Access Compliance Report

(Curb Ramps)

Intersection ID: 3415	Main Street: WHITEWOOD_TL	Cross Street: POPLAR GROVE DR	Location: SE
ADA ID: 9FE7AE27EBF3	Ramp Type: Perp	Initial Pass/Fail: Fail	Overall Compliance: No
Severity Score: 46.25			
Codes/Mitigation Info/Possible Solution		Field Measurements/Component Compliance

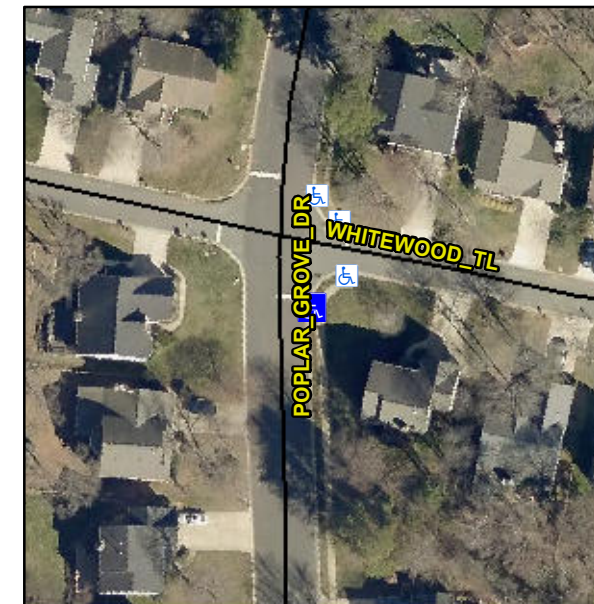
Not Found, R304.5.1, R304.2.2, R304.5.3

Compliance	Description	Data	Compliance	Description	Data
N/A	Ramp Length (in)	48.0	No	Ramp Slope (%)	9.0
No	Ramp Width (in)	46.5	No	Ramp XSlope (%)	9.9
N/A	Flare Type LT	N/A	N/A	Flare Type RT	N/A
N/A	Flare Slope LT (%)	N/A	N/A	Flare Slope RT (%)	N/A
N/A	Flare Traversable LT?	N/A	N/A	Flare Traversable RT?	N/A
N/A	Landing Length (in)	N/A	N/A	DWS Provided?	N/A
N/A	Landing Width (in)	N/A	N/A	DWS Contrast?	N/A
N/A	Landing Slope (%)	N/A	N/A	DWS Length (in)	N/A
N/A	Landing X Slope (%)	N/A	N/A	DWS Full Width?	N/A
N/A	Landing Curb? (Y/N)	N/A	N/A	DWS Offset (in)	N/A
N/A	Shared Landing?	N/A			
N/A	Gutter Ponding?	N/A	N/A	Gutter Slope (%)	N/A
N/A	Gutter Lip Ht (in)	N/A	N/A	Gutter X Slope (%)	N/A
N/A	Painted X Walk1?	No	N/A	Painted X Walk2?	N/A
	X Walk 1 Direction	To W		X Walk 2 Direction	N/A
N/A	X Walk 1 Width (in)	N/A	N/A	X Walk 2 Width (in)	N/A
	X Walk 1 Slope (%)	4.2		X Walk 2 Slope (%)	N/A
	X Walk 1 X Slope (%)	9.1		X Walk 2 X Slope (%)	N/A

Remove & Replace Entire Ramp.
